Project	IEEE 802.16 Broadband Wireless Access Working Group < http://ieee802.org/16 >	
Title	Embodied traffic indication during sleep-mode	
Date Submitted	2004-07-15	
Source(s)	<p>Kanggyu Lee, Jina Kim, Sungwook Park, Yunsung Kim, Taein Hyon, Yunsang Park, Yeongmoon Son Samsung Electronic</p> <p>Yongjoo Tcha, Min-Sung Kim, Seong-Choon Lee KT</p> <p>Sang-Yun Han, Jae-Hak(Steve) Lee SOLiD Tech., Inc.</p>	<p>Mail to: leekg@samsung.com ym1004.son@samsung.com yjtcha@kt.co.kr syhan@st.co.kr</p>
Re:	This contribution is for call for contribution about IEEE P802.16e/D3-2004	
Abstract	This contribution proposes the enhanced MOB_TRF-IND message and scenario for sleep mode. This is a contribution which is harmonized with comment #308(contribution C80216e-04_207).	
Purpose	Adoption as part of Handover Ad-hoc recommendation to IEEE802.16e	
Notice	This document has been prepared to assist IEEE 802.16. It is offered as a basis for discussion and is not binding on the contributing individual(s) or organization(s). The material in this document is subject to change in form and content after further study. The contributor(s) reserve(s) the right to add, amend or withdraw material contained herein.

Figure 1 Example of Modified MOB_TRF-IND message

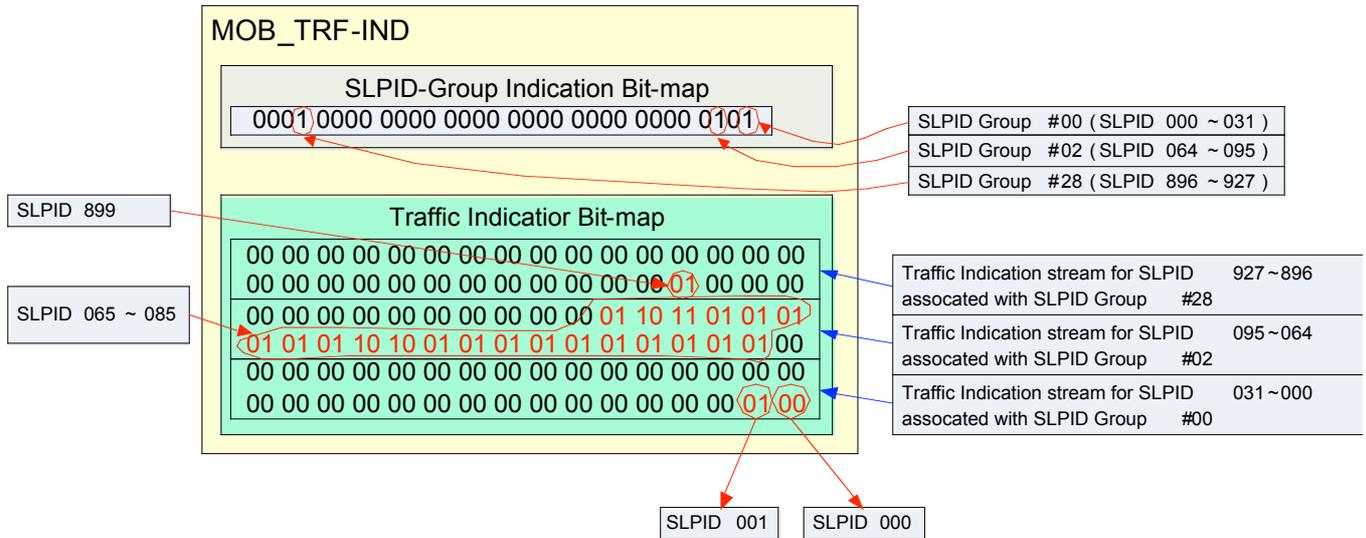
For example, assume that a BS has to wake up MSSs with their SLPID '0', '1', '65 through 85' and '899'. 'Then the Group Indication bits corresponding to SLPID-Group #0, #2 and #28 shall be set to '1', and three 64-bit Traffic Indicator streams are included in MOB_TRF-IND message. As a result, the Group Indication bit-map is set to 0x10000003 (=00010000 00000000 00000000 0000 0101b). The Traffic Indicator bit stream for SLPID #28 shall be set to 0x0000000000000004 and 0x000006D556955554 for SLPID-Group #2, and then 0x0000000000000004 for SLPID-Group #0. (refer to figure 1)

SLPID =0, 1 belong to SLPID - Group #0, There will be a DL traffic for SLPID =1.
 SLPID =65~85 belong to SLPID - Group #2. There will be DL traffics or Periodic Ranging for SLPID =65~85.
 SLPID =899 belongs to SLPID - Group #28, There will be a DL traffic for SLPID =899.
